**RE: RESPONSE TO INFORMATION REQUEST - A006698906
SECTION 13.2 OF THE DEVELOPMENT ASSESSMENT RULES
341 BECKETT ROAD, BRIDGEMAN DOWNS QUEENSLAND 4035**

We act on behalf of Steve Brown Constructions Pty Ltd and Mei Wah Wong, the Applicant in relation to a Development Application lodged with Brisbane City Council under the *Planning Act 2016* (the Planning Act) over the above land seeking:

- Development Permit for Reconfiguring a Lot (2 lots into 22 lots and new road)

Figure 1: Original Submitted Plan

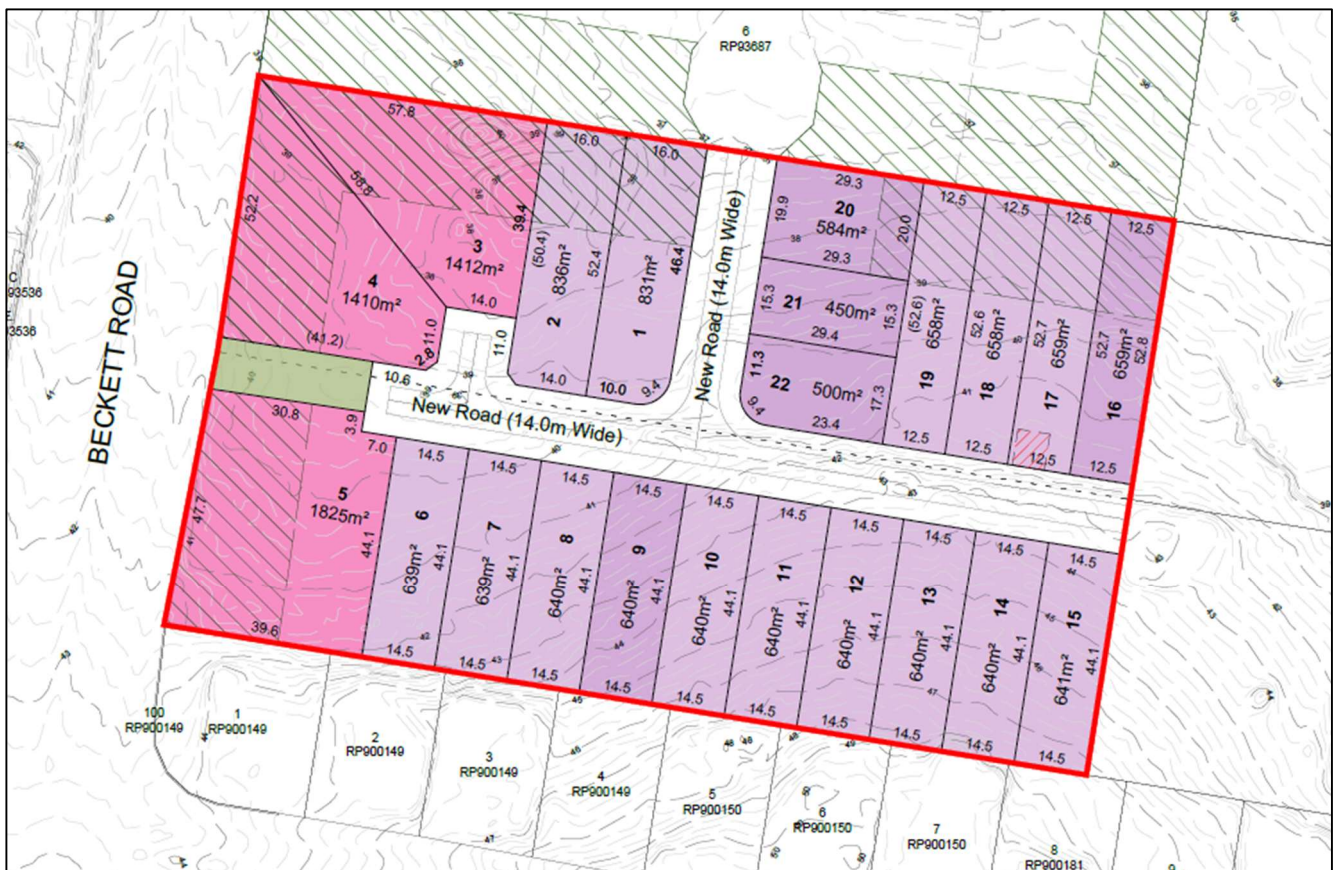
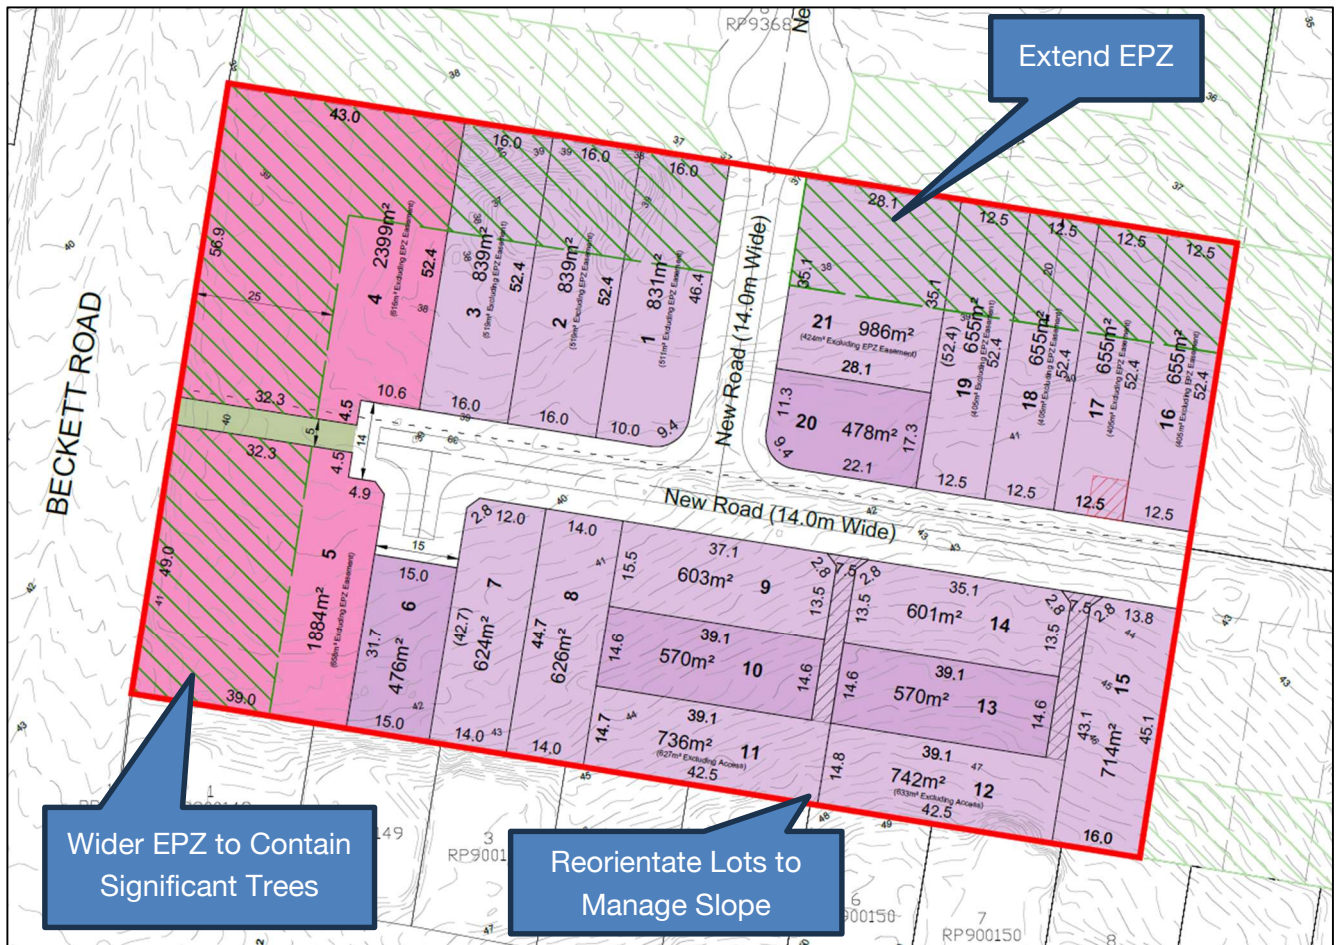
- Total loss of 1 lot overall, resulting in a 2 into 21 lot subdivision;

- Increase in Environmental Protection Zone (EPZ) widths along the Beckett Road frontage from 20m to 25m. This has resulted in retention of significant trees within this zone and provides a consistent 'green' zone along Beckett Road that maintains and enhances the street amenity;

- Extension of the EPZ along the northern boundary, resulting in the removal of 1 allotment;
- Minor amendments to internal road design as a result of earthworks, suitable building pads and refuse vehicle turnarounds;

- Lots 9-14 orientated east-west and utilising a shared driveway arrangement. This is to manage the slope in this area of the site and not have to rely on battering or large retaining structures. Smaller retaining structures occur on lot boundaries without impacting amenity of each lot;

- Decrease in pedestrian link width between lots 4 and 5 from 10m to 5m to increase environmental protection zone.

Figure 3: Structure Plan

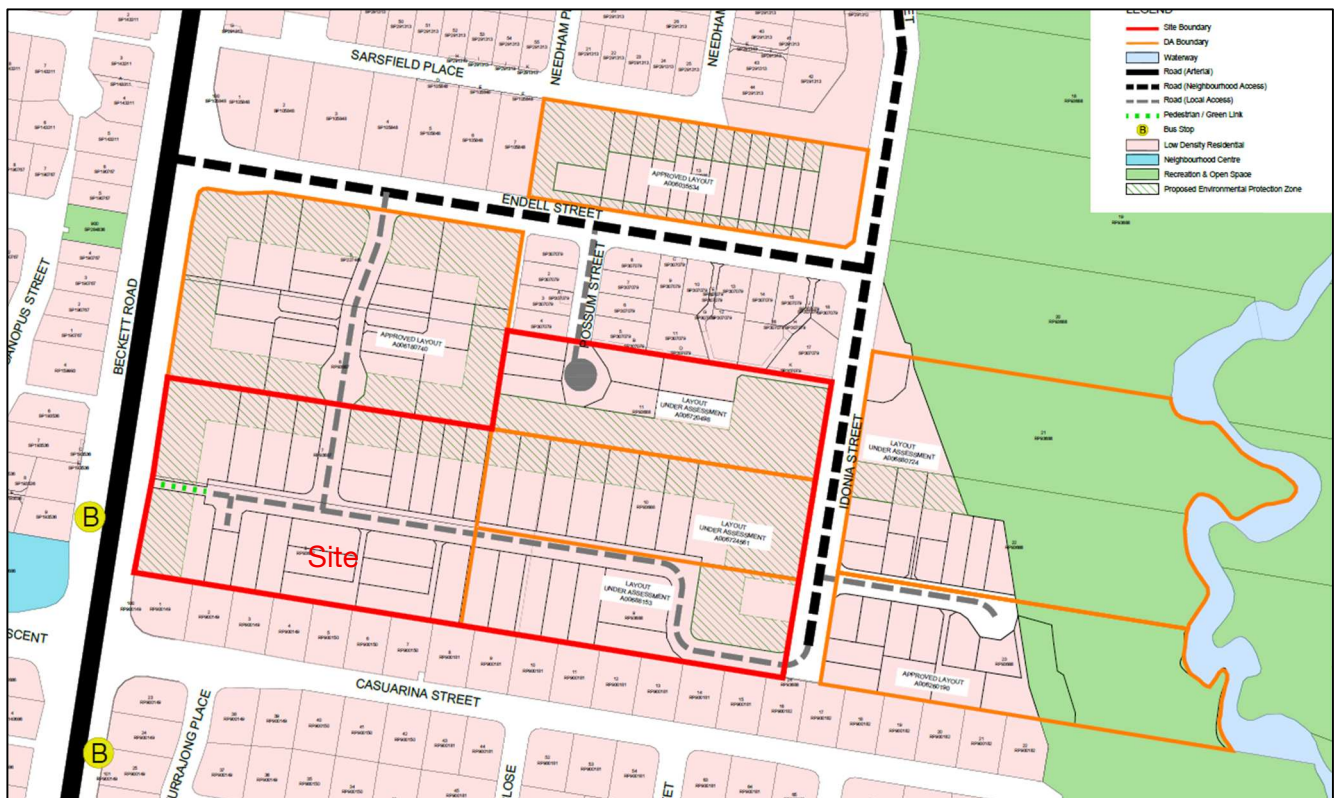
- 1) Council is concerned that the proposal is out-of-sequence as it relies upon the road corridor and stormwater infrastructure to be provided by 357 and 365 Beckett Road (Lot 6 on RP 93687 and Lot 5 on SP227448) or 113 and 117 Idonia Street (Lot 10 on RP93688 and Lot 9 on RP93688) for access to all lots. Whilst Council is currently assessing development applications for 113 and 117 Idonia Street, and notwithstanding there is a current approval over 357 and 365 Beckett Road, there is no certainty that these developments will ultimately go ahead. This issue will require further interrogation and understanding. More specific issues with respect to sequencing is detailed below.

Response: The Applicant has engaged with Council officers regarding the sequencing of development to confirm that the development proposal is a logical infill development. Where in similar situations the sequence of events for infill development includes relying on road access and infrastructure (water, sewer and stormwater) in order to deliver the development. This development application would be in the same situation as most, relying on the northern

development (A006180740) before commencing works. At a prelodgement meeting held with Council this position was agreed upon (in writing) to progress this application on the above basis. To support the above an updated structure plan labelled with each approval and application reference is attached herein to confirm how each development interlinks with each other. Refer to **Attachment B**.

Figure 4: Structure Plan

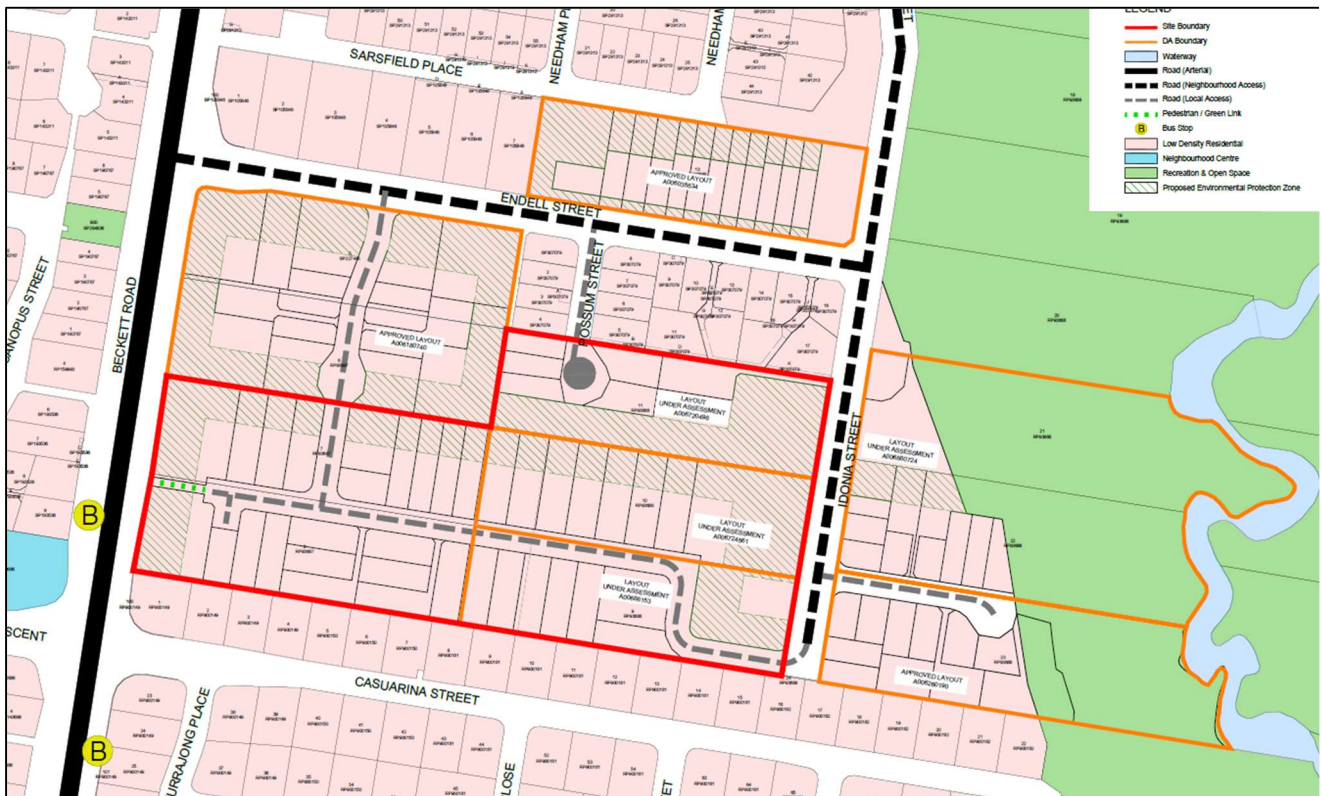
- a) A reduction in the number of lots and rearrangement of proposed lot boundaries to maximise vegetation retention and strengthen ecological corridors. Vegetation must be contained in large lots with BLEs adequately set back from vegetation and outside of the Tree Protection Zones (TPZs) of trees to be retained (considering existing vegetation and mature vegetation established as part of ecological restoration efforts).

- b) Retention of additional areas of vegetation including the following:
 - i. Proposed Lots 15 and 16 must be amalgamated with Lots 14 and 17 respectively to provide a minimum 15m wide EPZ along the entirety of the eastern boundary which retains and restores ecological values and connectivity to adjoining properties.

- ii. Proposed Lot 20 must be amalgamated with a surrounding lot and provided as an EPZ to strengthen ecological connectivity, and retain and restore ecological values.

- iii. The existing dam and all fringing vegetation within the EPZ of proposed Lots 2 and 3 must be retained and restored, and wholly contained within the EPZ of one (1) lot.

- iv. The highest value koala habitat area has been identified as the north-eastern corner of the site, and additional koala habitat trees must be retained within the EPZ at this location.

- v. Additional retention of vegetation within areas of mapped HES must be attempted wherever possible (i.e. south-west corner of site).
- c) The number of lot owners of EPZ areas must be minimised to reduce the amount of lot severance that is created and maximise cohesive restoration outcomes.

Response: The ecological report has not been updated for the amended layout. Nonetheless the following changes are made to the plan and are considerate of the existing ecological features (mapped and ground truthed):

- Increase EPZ width to 25m along Beckett Road frontage to retain larger trees;
- Extension of the EPZ along the northern boundary.

Significant consultation has occurred with both SARA and Brisbane Council planning officers to moderate an outcome for the subject site and the area overall. This has provided a balanced outcome to achieve much needed residential development within an infill site with significant environmental values. It is considered through the provision of rehabilitated environmental protection zones, the environmental values of the area are improved add both to the amenity and biodiversity of the area.

The below structure plan provides an overall picture of how environmental corridors are being achieved, particularly north-south along Beckett Road and East-West towards Cabbage Tree Creek.
